Axia Studio Engine Compact Flash Replacement

24 July 2007, Cleveland Ohio, USA

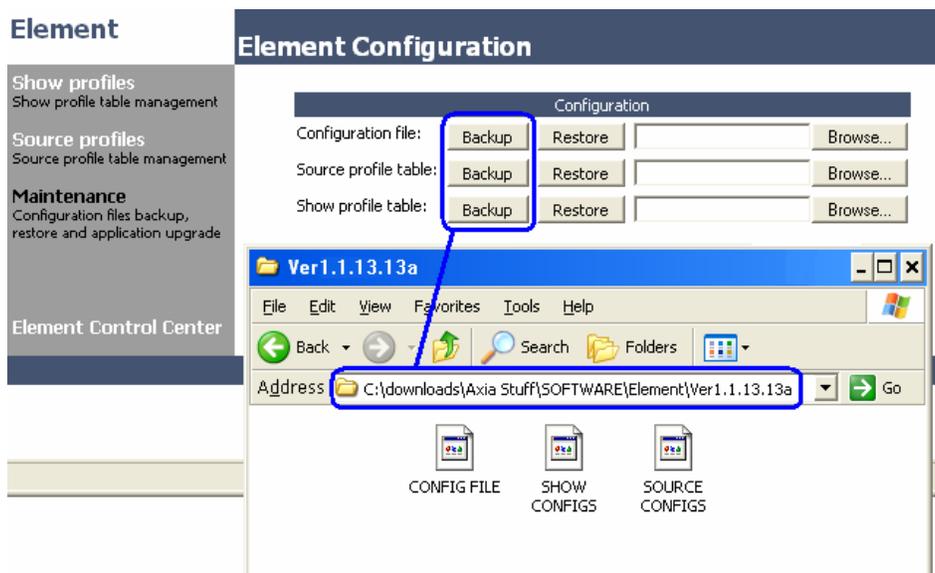
- 1) Log into the Engine's web pages, and capture screen shots of the following pages as shown in the screen capture below. The best way to capture these screen shots is to use the save the viewed page as an HTML file. This is a standard feature in most web browsers.
 - a) Program and Monitor Outputs
 - b) V-Mixer and GPO
 - c) Engine ID
 - d) Console ID

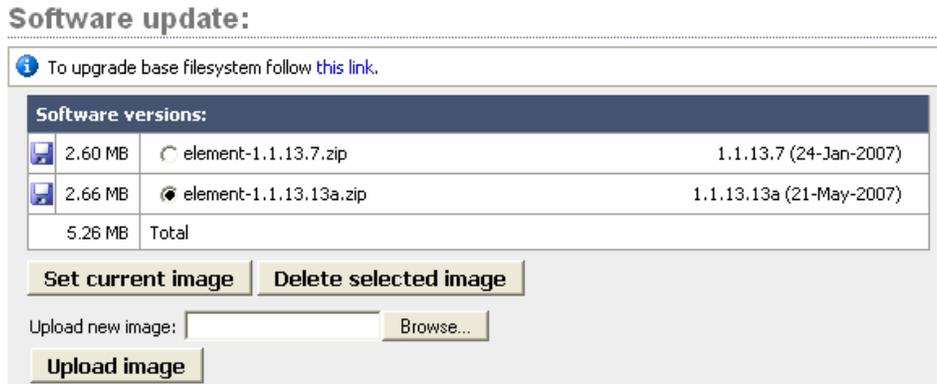
- 2) Upgrade the Element Software to 1.1.13.13a. (NOTE: versions prior to 1.1.13.7 need to follow the steps to upgrade to 1.1.13.7 first)
 - a) Create backup profiles in a version specific directory for the current running version of Element before doing any upgrades.

- b) If you need to upgrade the Element software revisions they can be downloaded from the following links:

Current release v.1.1.13.13a: <http://www.axiaaudio.com/downloads/default.htm>
 Link to v.1.1.13.7: http://www.axiaaudio.com/downloads/dload_element.htm

- c) Upload new Element software, set it as the current image, and reboot.
